DEPARTMENT OF THE AIR FORCE
45TH SPACE WING (AFSPC)

SUBJECT: Rail Extension to Port Canaveral, Florida – Potential Rail Alignments
 (Your letter, 20 Feb 15)

Re: Docket No. FD 35852, Canaveral Port Authority — Rail Line Extension to
Port Canaveral, Florida — Potential Rail Alignments

Proposed CCAFS Rail Alignments

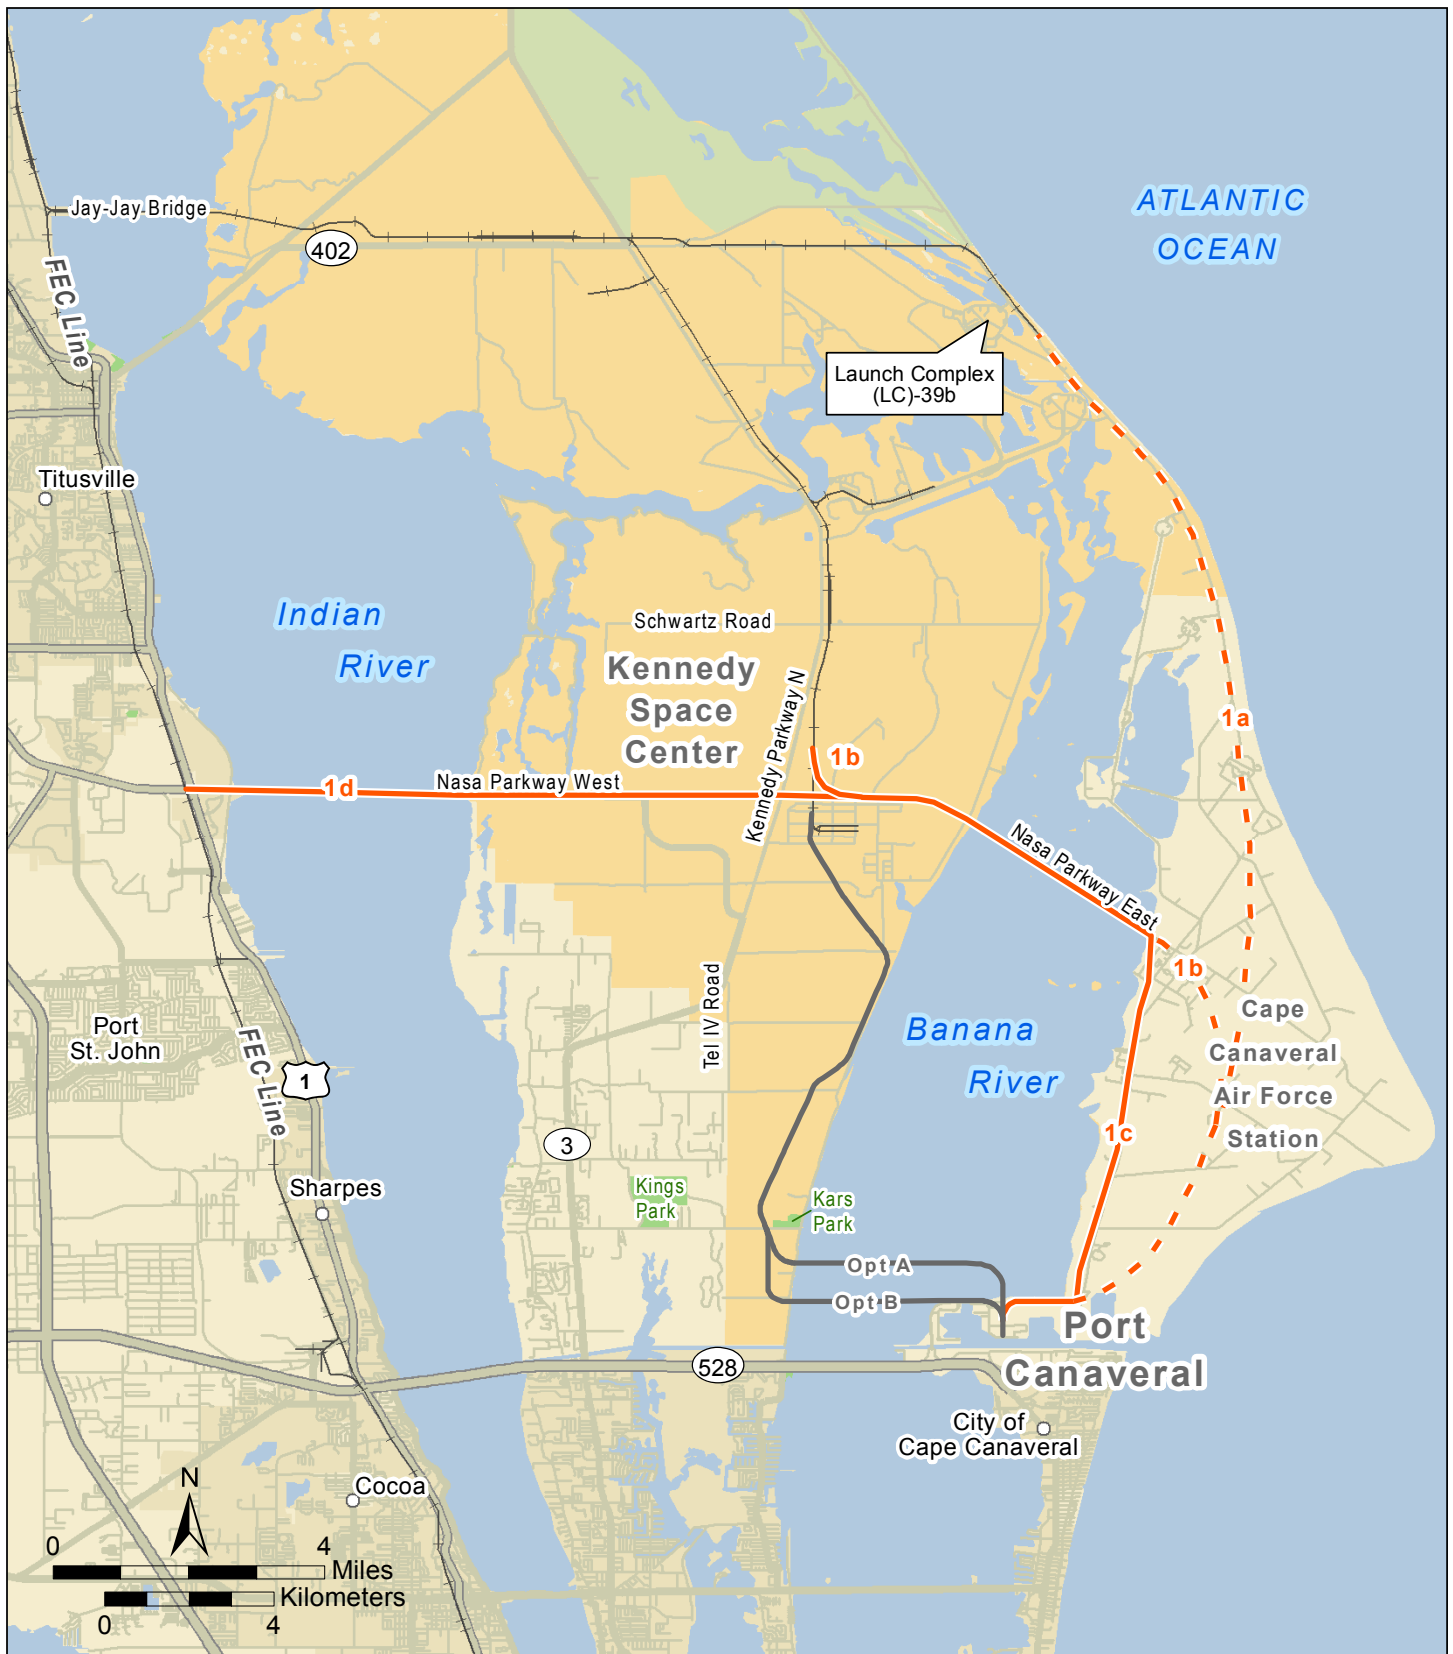
2. Routes referred to as 1a and 1b of your letter are not considered feasible because in both of these scenarios, the route crosses the CCAFS airfield; rendering that facility unusable to support our mission. In addition, route 1a is shown running past our critical launch complexes 37, 40 and 41. Any route proposed in proximity to these complexes would likewise be considered not feasible due to safety, security and hazardous operations related to those facilities.

3. Based on the information provided, it is not possible to evaluate the feasibility of route 1c running along CCAFS's western transportation corridor. Due to the multiple hazardous operating facilities, critical telemetry and radar equipment, and cultural and natural resources located along the route, the 45th Space Wing would require the Surface Transportation Board to provide a planning assessment, similar to the one performed for the NASA routes, in order to evaluate potential mission impacts and possible mitigation strategies before such a determination could be made. We do not have any comment on route 1d since it traverses Kennedy Space Center (KSC) and is not CCAFS property.

4. In summary, none of the proposed rail routes that traverse CCAFS property are currently feasible without further study. We look forward to working with Surface Transportation Board and reviewing any assessments you can provide to further evaluate the overall feasibility of any rail route that traverses CCAFS. If you have any further questions, please contact me directly at 321-494-3398 or via e-mail at Thomas.Eye@us.af.mil .
